Access Compliance Report

Public Rights-of-Way

(Pedestrian Signals)

Intersection ID: N/A	Main Street:	Cross Street: N/A	Location: N/A
ADA ID: F9BD5BBF5ECD	Signal Type: One Push Button-Non APS	Overall Compliance: No	Severity Score: BTN 1: N/A BTN 2: N/A No BTN: N/A
Codes/Mitigation Info/Possible Solution		Field Measurements/Component Compliance

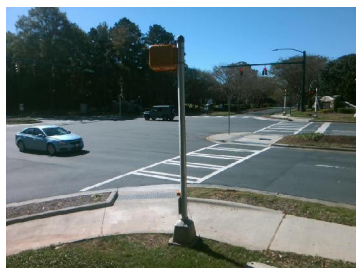
PROW/ADA: R209.1, TMUTCD 4e.08, R404.2, R404.7.3

Yes	B 1 Clear Xing Direction?	ClearlyMarked	N/A	B 2 Clear Xing Direction?	N/A
	B 1 Crossing Direction	To W		B 2 Crossing Direction	N/A
No	B 1 DistanceTo XWalk (in)	90.0	N/A	B 2 DistanceTo XWalk (in)	N/A
No	B 1 DistanceTo Curb (in)	148.0	N/A	B 2 DistanceTo Curb (in)	N/A
Yes	B 1 Diameter (in)	2.0	N/A	B 2 Diameter (in)	N/A

Possible Solutions: Replace Signal Push Button With APS Button on New Post. Remove & Relocate Sign.
